IEEE P802.15 Wireless Personal Area Networks

Project	IEEE P802.15 Working Group for Wireless Personal Area Networks (WPANs)		
Title	Proposed Text on π/2 BPSK and (G) MSK description		
Date Submitted	September, 9 th , 2008		
Source	[R. Funada]	Voice: Fax: E-mail:	[[+81-46-847-5055] [[+81-46-847-5440] [funada@nict.go.jp]
Re:	802.15.3c Teleconference Meeting		
Abstract	IEEE 802.15 Task Group TG3c Comment Resolution		
Purpose	Resolutions for the $\pi/2$ BPSK and (G) MSK description		
Notice	This document has been prepared to assist the IEEE P802.15. It is offered as a basis for discussion and is not binding on the contributing individual(s) or organization(s). The material in this document is subject to change in form and content after further study. The contributor(s) reserve(s) the right to add, amend or withdraw material contained herein.		
Release	The contributor acknowledges and accepts that this contribution becomes the property of IEEE and may be made publicly available by P802.15.

12.2.2.1.1 π /2 BPSK, Pre-coded (G)MSK

Figure 189—Constellation maps for modulation schemes: (a) π /2 BPSK, (b) pre-coded MSK/GMSK, (c) π /2 QPSK

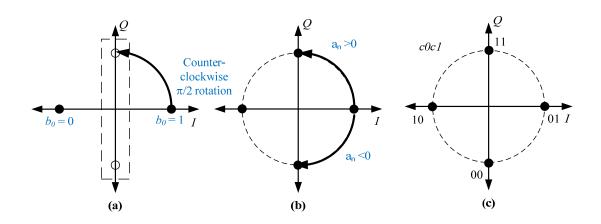
The $\pi/2$ -shift BPSK ($\pi/2$ BPSK) modulation uses two phases separated by π radian, as illustrated in Figure 189(a). The $\pi/2$ phase shift is made counter-clockwise to eliminate the π phase shift. Figure 189(a) shows signal constellation of $\pi/2$ BPSK signals. As shown in Figure 189(a), the black dot indicates the initial constellation point on the horizontal axis. In the next bit timing, the black dot is rotated to either hollow dot on the vertical axis. If b_0 , b_1 , ..., b_{n-1} are unipolar bits to be transmitted, they are mapped to bipolar bits d_0 , d_1 , ..., d_{n-1} , where bit "0" is mapped on "-1" and bit "1" on "+1". The bipolar bit stream is then mapped onto constellation points z_n as

Pre-coded MSK are continuous phase modulation schemes by applying differential pre-coding before the MSK modulation. Note that the MSK constellation mapping is approximately equivalent to the $\pi/2$ -BPSK constellation as shown in Figure 189(b). The differential pre-coding is defined by

where, z_{-1} is -j. This encoding means the odd bits are mapped onto the real axis and the even bits are mapped onto the imaginary axis, as shown in Figure 189(b). Hence it is equivalent to the $\pi/2$ -BPSK constellation as shown in Figure 189(a) (Note that the normalization factor is 1). The maximum phase shift of MSK is equal to $\pi/2$ radian. The maximum phase shift of GMSK is equal to or less than $\pi/2$ radian due to Gaussian filtering. Note that filtered waveform of each modulation shall satisfy Transmit PSD mask as in 12.2.7.4.
